HISTORIC AND DESIGN REVIEW COMMISSION

June 06, 2018

HDRC CASE NO: 2018-235
ADDRESS: 203 W MULBERRY AVE
LEGAL DESCRIPTION: NCB 3059 BLK 6 LOT 22 & E 16.67 FT OF 21
ZONING: R-5 H
CITY COUNCIL DIST.: 1
DISTRICT: Monte Vista Historic District
APPLICANT: Luis Carrillo
OWNER: Duncan Ncada
TYPE OF WORK: Construction of a second story addition on rear accessory structure, exterior modifications
APPLICATION RECEIVED: May 11, 2018
60-DAY REVIEW: July 10, 2018
REQUEST:

1. Construct a 1-story rear addition to the primary structure.
2. Construct a second story addition atop the existing rear accessory structure.

Proposed Floor Plans (Apartment Studio)

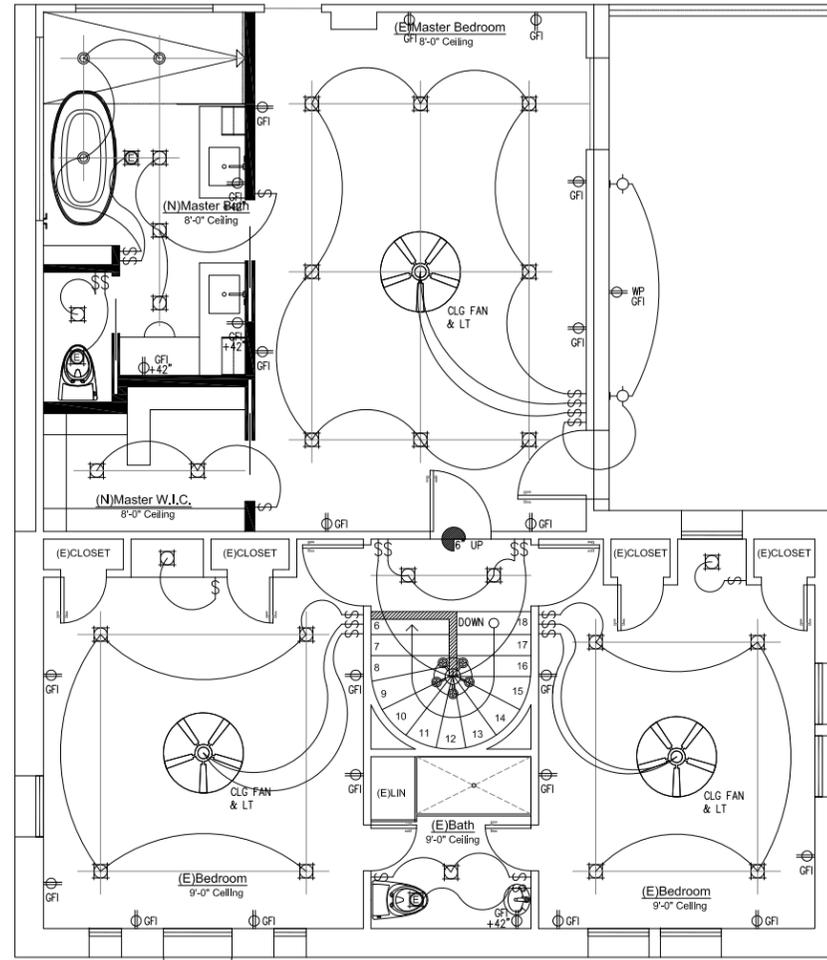
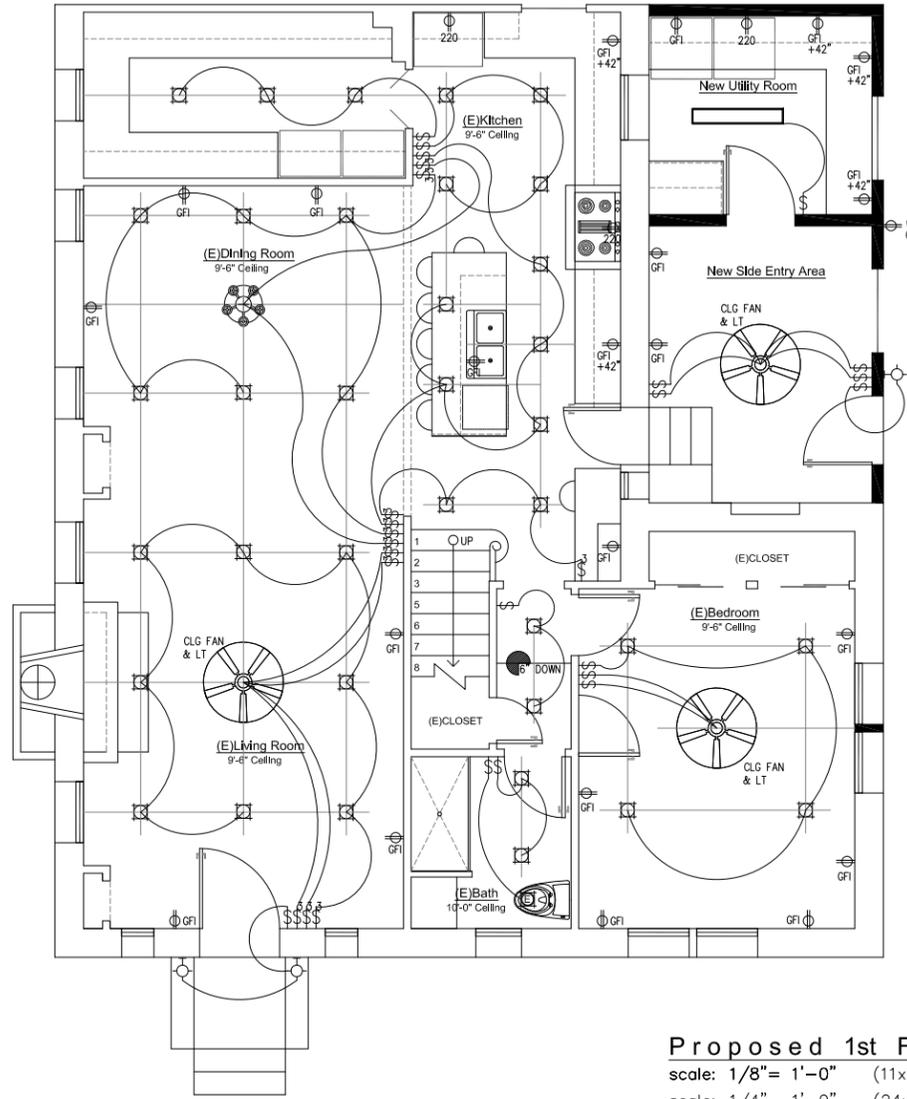
- i. SETBACKS – The existing accessory is a one-story garage set behind the main residential house. The garage is accessible from the side street on Howard St. The existing garage has a rear and a side setback of approximately 0'. The proposed addition will be flush with the existing walls and has a rear setback of 0'. According to the Guidelines for New Construction 5.B.ii., historic setback pattern of similar structures along the block should be followed. In this instance, historic setbacks are not consistent with UDC requirements and a variance is required. Staff finds that the proposed setbacks are consistent with the historical development pattern along the block.

- j. SCALE AND MASS – The existing garage structure is one-story and is approximately 680 square feet. The proposed addition creates a two-story structure and adds approximately 800 square feet. According to the Guidelines for Additions 1.B.i, additions should be designed to be visually subordinate to the principal structure in terms of their height, massing, and form. Staff finds that the addition does not overwhelm or visually compete with the main structure. Additionally, several historic 2-story accessory structures exist along Howard St, several located directly on the side lot line. Staff finds the proposal consistent with the Guidelines.

- k. ROOF – The existing roofline of the one-story garage is flat with a raised parapet and barrel tile coping. The proposed 2nd story addition features a low sloped hipped roof, similar to the primary structure, with red shingles. According to the Guidelines for Additions 1.A.ii., similar roof forms, pitches, and overhangs should be used on additions. Staff finds the proposal generally appropriate for the structure and its relationship to the primary structure.

- l. TRANSITIONS AND MATERIALS – The proposed addition will utilize a white stucco finish to match existing. According to the Guidelines for Additions 1.A.iv., the addition should feature a visual distinction between old and new building forms, whether it is an offset of the material or an architectural element. The

guidelines also stipulate to use materials that are compatible with the existing structure. Staff finds the proposed stucco to be generally appropriate for the structure.

- m. **EXISTING WINDOWS** – The applicant has not stated that existing assemblies will be modified. Staff finds that all existing windows should be retained and restored. The applicant is required to provide a comprehensive narrative for the treatment of these windows for final approval.

- o. **STAIRCASE** – The applicant has proposed to install a staircase leading from the existing first story to the new second story. The staircase will be located on the side (south) façade and rear façade of the structure. The material has not been indicated at this time. Staff finds the proposed location of the staircase to be conceptually appropriate, but requires substantial detail for final approval, including materials and dimensions. Staff finds that the staircase and its elements, including railings and balusters, should be constructed of wood.

- p. **ARCHITECTURAL DETAILS** – According to the Guidelines for Additions 4.A.ii., the addition should incorporate architectural details that are in keeping with the style of the original structure but an element reflective of its time. New details should be simple relative to the primary structure and should not impart a sense of false historicism. Staff finds that the quoin detailing added to the corners of the structure is incongruent with the Guidelines. Staff finds that this detail should be eliminated.

- ii. That the applicant submits complete elevation drawings for final approval.
- iii. That new windows be one over one configuration and be made out of wood and meet the following specifications: meeting rails must be no taller than 1.25” and stiles no wider than 2.25”. There should be a minimum of two inches in depth between the front face of the window trim and the front face of the top window sash. This must be accomplished by recessing the window sufficiently within the opening or with the installation of additional window trim to add thickness. Window trim must feature traditional dimensions and architecturally appropriate sill detail. Window track components must be painted to match the window trim or concealed by a wood window screen set within the opening. The applicant is required to submit a specification for final approval.
